City of Charleston

BOARD OF ARCHITECTURAL REVIEW - LARGE

January 22, 2020

Agenda Item #4

CONTEXT

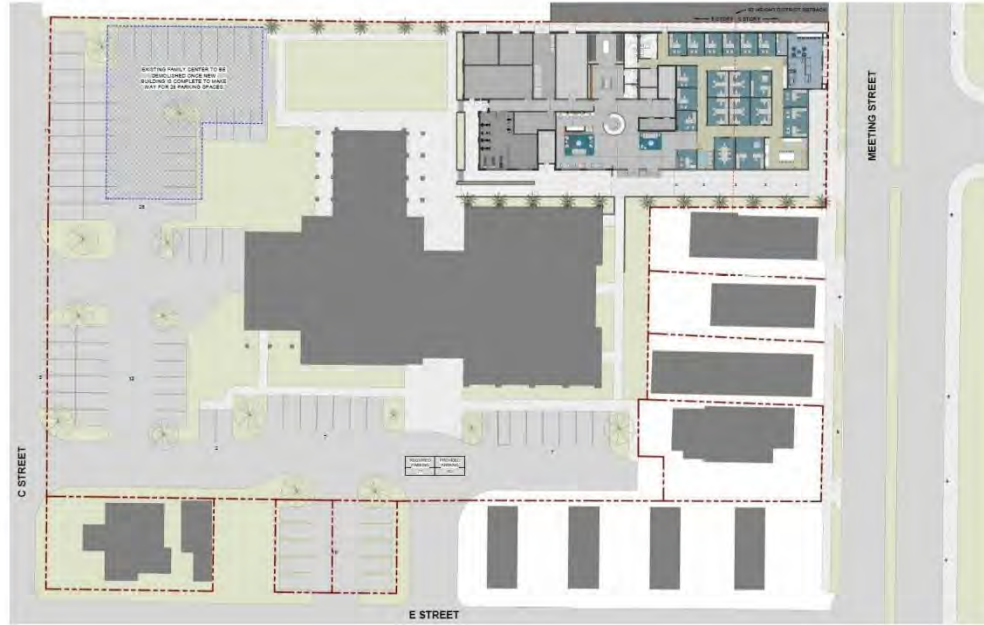
CONCEPTUAL BAR COMMENTS (1/14/2018)

STAFF COMMENTS:

- STUDY A WAY TO BREAK UP THE LONG MASS OF THE N. ELEVATION
 - PORTION OF BUILDING HAS BEEN RECESSED FROM FLOORS 3-7
- THE BRICK OF THE 3-STORY MASS FEELS MORE LIKE A SURFACE TREATMENT THAN A SUBSTANTIAL MASONRY MATERIAL. IN PART DUE TO THE DIMENSION FROM THE FACE OF BRICK TO STUCCO. CONSIDER AN ALTERNATE MATERIAL OR INCREASE IN THE DEPTH OF BRICK, WHICH WOULD HELP THE WINDOWS TO BE SET DEEPER

- ALSO, THE THIN COLUMNS VISUALLY SUPPORTING THE MASS ABOVE IS UNCOMFORTABLE AND SHOULD BE RESTUDIED
 - HEIGHT OF MASS ABOVE THE SIDEWALK HAS BEEN LOWERED AND THE COLUMNS HAVE BEEN REMOVED

- IT WOULD BE BEST FOR THE SPANDRELS TO BE METAL TO MATCH THE STOREFRONT RATHER THAN FIBER CEMENT. THIS SHOULD ALSO OCCUR AT THE SIDING AT THE TOP FLOOR OF THE BUILDING

- MAJORITY OF THE WINDOWS ARE NOW FIXED ONE OVER ONE DOUBLE HUNG WINDOWS
- A PERFORATED SCREEN IS A GOOD SOLUTION TO SCREEN THE P-TAC UNITS. ALTHOUGH V-TAC UNITS ARE CALLED OUT ON THE DRAWINGS AND WOULD BE PREFERRED IF P-TAC UNITS ARE NECESSARY, IT WOULD BE NICE FOR THE SCREENS TO BE A COLOR THAT WOULD PROVIDE SOME "LIFE" AND "WARMTH" TO THE BUILDING. ALSO, STUDY THE LOUVERS NOT CONCEALED BY SCREENS.

BOARD COMMENTS:

1. BREAK UP THE NORTH ELEVATION
2. USE MATERIAL OTHER THAN FIBER CEMENT
3. TRY TO BETTER HIDE V-TAC LOUVERS NOT BEHIND SCREEN
4. ENTIRE 3-STORY FACADE ON MEETING ST. COULD BE BRICK
5. COLUMNS ON EAST AND SOUTH ARE TOO SLENDER
6. BUTTERFLY ROOF IS A DEFINING ELEMENT AND SHOULD BE MORE BOLD AND BETTER DETAILED

- THE MAJORITY OF THE BRICK HAS BEEN REMOVED AND REPLACED WITH SHRAP SIDING TO BETTER RELATE TO THE RESIDENTIAL NATURE OF THE ADJACENT PROPERTIES AND CONTRAST THE SIX STORY PORTION OF THE BUILDING.

- THE PANELS REMAIN FIBER CEMENT BUT REVEAL JOINTS HAVE BEEN ADDED TO ALIGN WITH THE WINDOWS
- PENETRATION PATTERN LOOKS A LITTLE DATED AND COULD BENEFIT FROM AN ADDITIONAL VERTICAL MULLION AT EACH 1/1 WINDOW

- V-TAC UNITS WILL NO LONGER BE USED, ELIMINATING THE NEED FOR THE DECORATIVE SCREEN
- INFILLED WINDOWS ON THE W. SIDE WOULD BE BEST AS ALL LOUVER SCREENS VS. FIBER CEMENT

- INFILLED AREAS HAVE BEEN REMOVED AND REPLACED WITH METAL PANEL TO MATCH WALL
- PROVIDE INFORMATION FOR THE FENCE BETWEEN 573 AND 575 MEETING.
 - FENCE IS NOT REQUIRED PER ZONING AND HAS THEREFORE BEEN REMOVED AND REPLACED WITH LANDSCAPE

CONCEPTUAL BAR COMMENTS (11/14/2019)

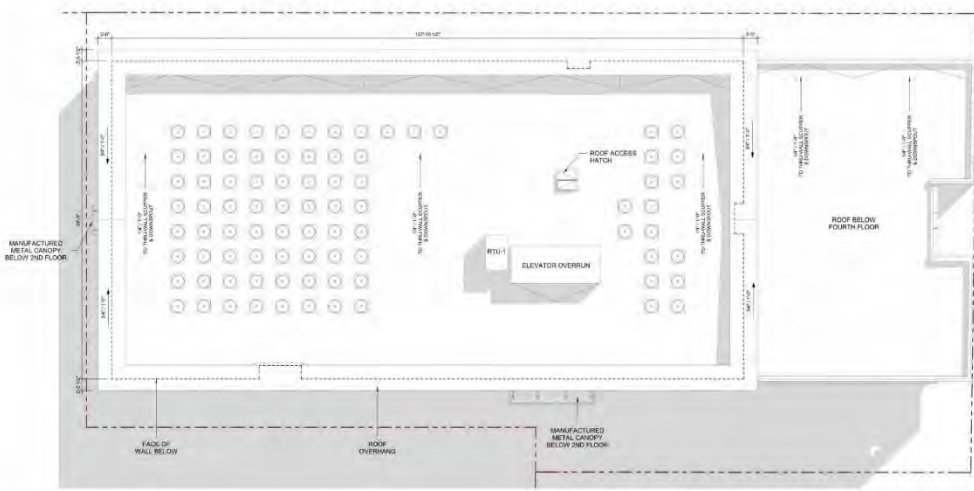
- THE PANELS REMAIN FIBER CEMENT BUT REVEAL JOINTS HAVE BEEN ADDED TO ALIGN WITH THE WINDOWS
- FENESTRATION PATTERN LOOKS A LITTLE DATED AND COULD BENEFIT FROM AN ADDITIONAL VERTICAL MULLION AT EACH 1/1 WINDOW

- MAJORITY OF THE WINDOWS ARE NOW FIXED ONE OVER ONE DOUBLE HUNG WINDOWS
- A PERFORATED SCREEN IS A GOOD SOLUTION TO SCREEN THE P-TAC UNITS, ALTHOUGH V-TAC UNITS ARE CALLED OUT ON THE DRAWINGS AND WOULD BE PREFERRED. IF P-TAC UNITS ARE NECESSARY, IT WOULD BE NICE FOR THE SCREENS TO BE A COLOR THAT WOULD PROVIDE SOME "LIFE" AND "WARMTH" TO THE BUILDING. ALSO, STUDY THE LOUVERS NOT CONCEALED BY SCREENS.

- INFILLED AREAS HAVE BEEN REMOVED AND REPLACED WITH METAL PANEL TO MATCH WALL
- PROVIDE INFORMATION FOR THE FENCE BETWEEN 573 AND 575 MEETING.
 - FENCE IS NOT REQUIRED PER ZONING AND HAS THEREFORE BEEN REMOVED AND REPLACED WITH LANDSCAPE

KEY BOARD COMMENTS FROM PRELIMINARY BAR (DEC. 2ND)

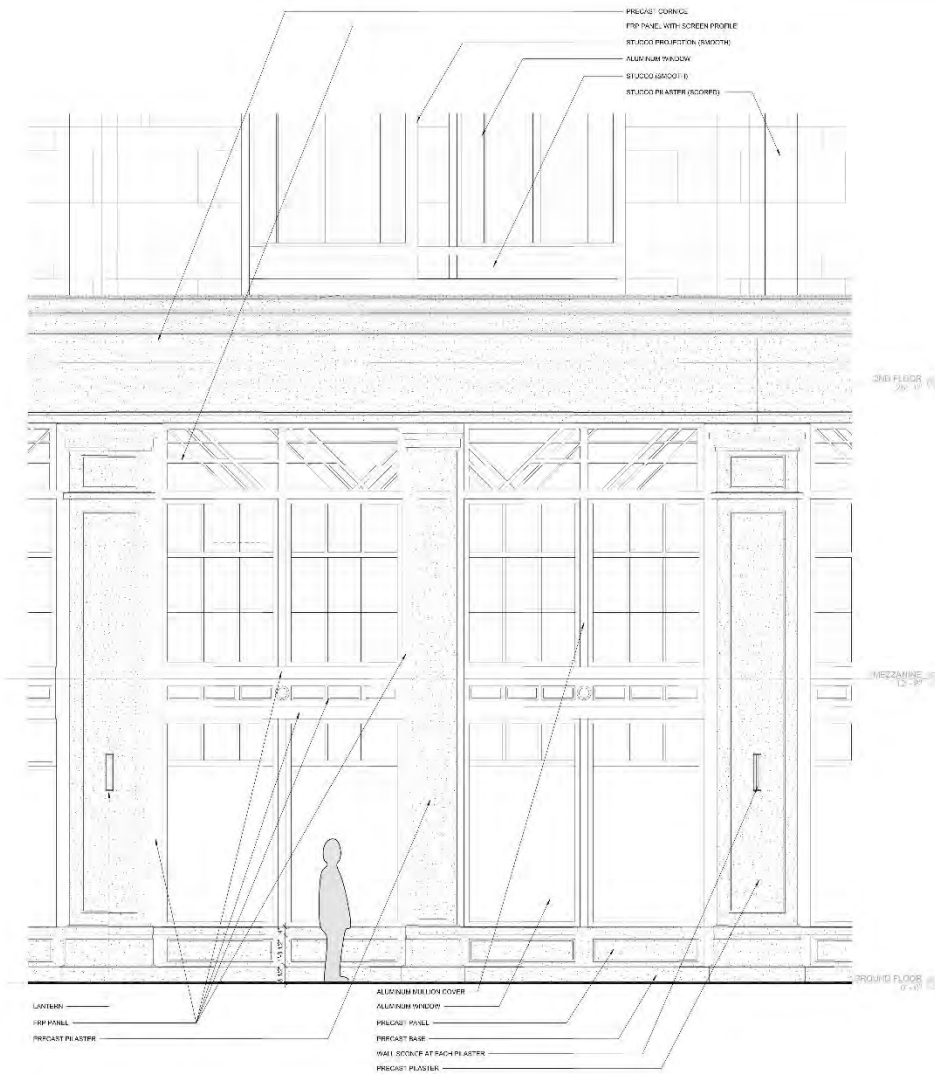
5. The entrance on Meeting St. will be a service entrance and best if eliminated
9. Reduce number of light fixtures to not every pilaaster.
11. Materials need to be upgraded as follows:
 - a. The base of the building up to the 2nd level cornice needs to be actual stone per the "principles".
 - b. There is a lot of FRP (plastic product) proposed for the building such as at balconies, brackets, canopies, cornices, panels, headers, recesses etc. This is contrary to the Board's directive on other large projects and should be upgraded and limited to the highest portions of the building if used at all.
 - c. Thermochromex stucco is an upgrade but must be resolved with the scored stucco and control joints.
 - d. Laser cut aluminum at the roof is an interesting way to screen mechanical.
 - e. Provide specialty paving between the property line and the building to ground the building.

KEY REFINEMENTS SINCE DEC. 2ND PRELIMINARY BAR

1. A granite watertable has been added at the base of the building.
2. All instances of FRP have been replaced with either GFRC or Aluminum Panel
3. The scored stucco joints have been removed.

KEY BOARD COMMENTS FROM PRELIMINARY BAR (DEC. 2ND)

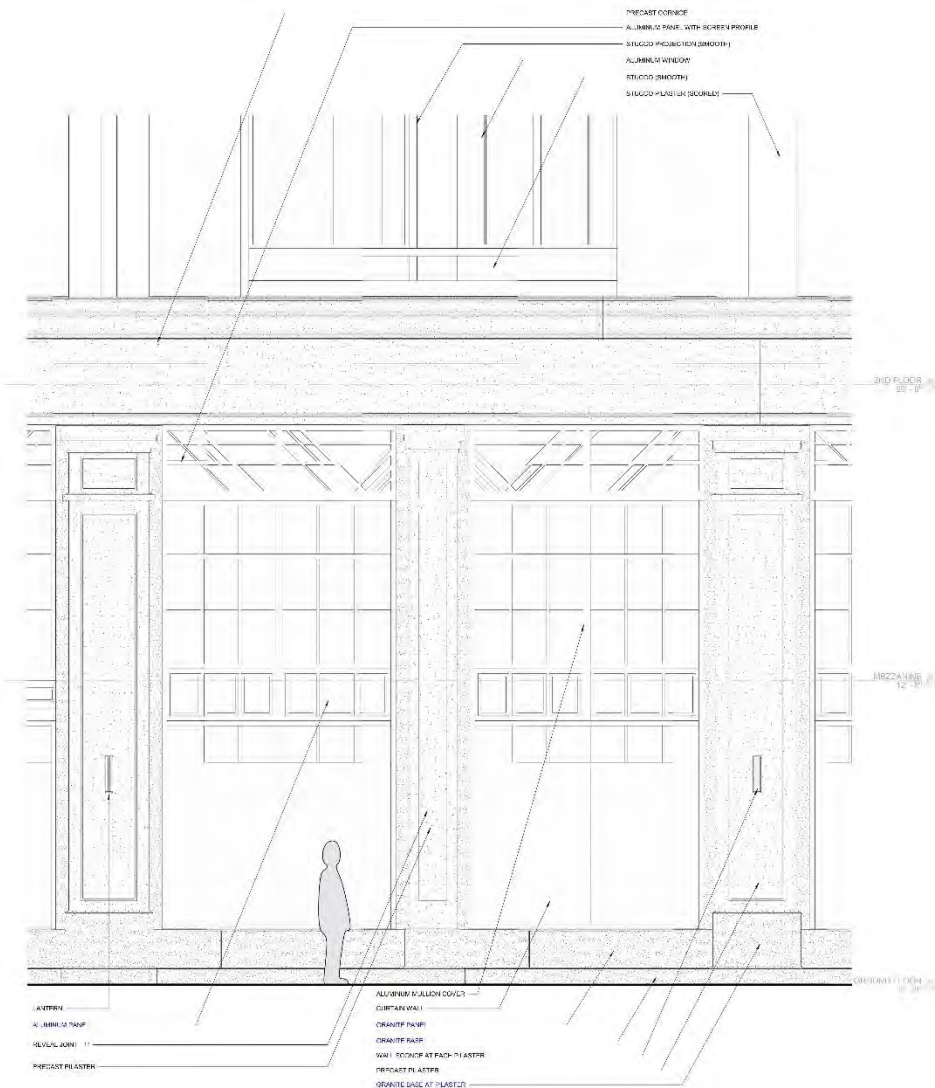
11. Materials need to be upgraded as follows:
 - a. The base of the building up to the 2nd level cornice needs to be actual stone per the "principles".
 - b. There is a lot of FRP (plastic product) proposed for the building such as at balconies, brackets, canopies, cornices, panels, headers, recesses etc. This is contrary to the Board's directive on other large projects and should be upgraded and limited to the highest portions of the building if used at all.
 - c. Thermochromex stucco is an upgrade but must be resolved with the scored stucco and control joints.

1. A granite watertable has been added at the base of the building.
2. All instances of FRP have been replaced with either GFRC or Aluminum Panel
3. The scored stucco joints have been removed.
